**CONTINUING ELIGIBILITY INSPECTION (CEI) REPORT
FOR HURRICANE & SHORE PROTECTION PROJECTS**

1. Project Name: Vatia Shore Protection Project
2. Date of Inspection: April 9, 2002
3. Inspection Personnel:

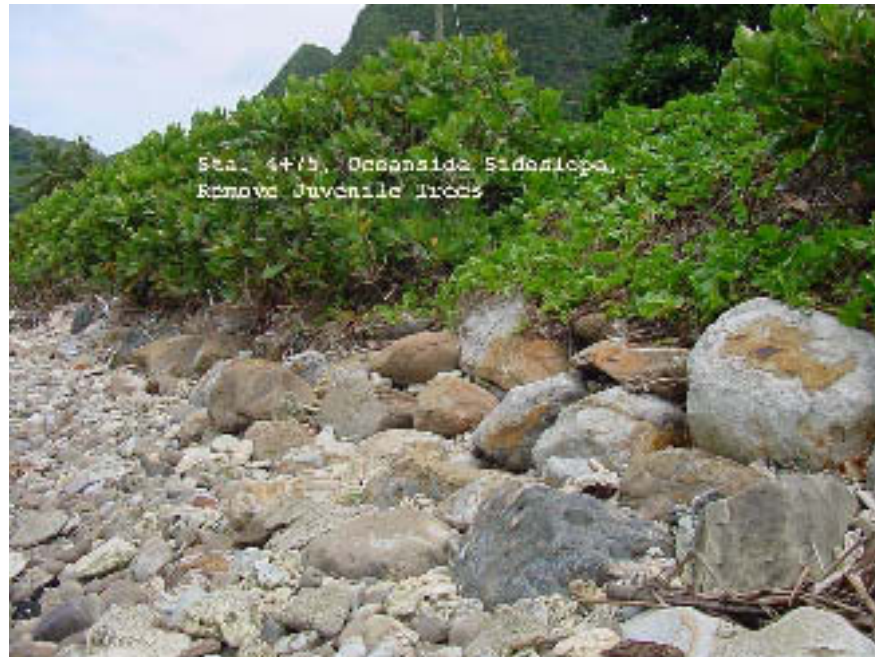
The SPP is 630 LF. Sta. 0+00 is the beginning of the structure, located at the West-End (Main Road Side) of the project. The project has been breached by the construction of a road at the West Side of the project. In general the maintenance of the project was considered good. All discrepancies were noted and brought to the representative's attention. The major deficiencies were as follows:

a. Sta. 0+50 Interior tieback, remove vegetation growing among interior toe stones.

b. Sta. 2+10 a 15', The coral road through the revetment is OK.

c. Sta. 1+80, Remove vegetation that covers structure.

d. Sta. 2+50 to 5+00, Remove juvenile trees from the sideslope.
 Note: A coral beach is forming immediately in front of the revetment
 with a beach berm up to two feet MLLW.

e. Sta. 2+90, Trees on sideslope need to be removed.

f. Sta. 3+90, Trees on sideslope need to be removed.

g. Sta. 4+75, crest one split armor stone.

h. Sta. 4+80, a 15' coral road has been laid over the crest of the revetment. Not a problem as crest elevation was not reduced.

i. Sta. 5+25 - Sta. 6+30, Remove a large ulu (breadfruit) tree and other juvenile trees growing among the armor stones at the crest.

j. Sta. 6+30 tieback, house is located approximately three feet from the toe of the structure.

The focus of the maintenance required should be directed at vegetation control. Removal or herbicides are recommended in lieu of cutting.
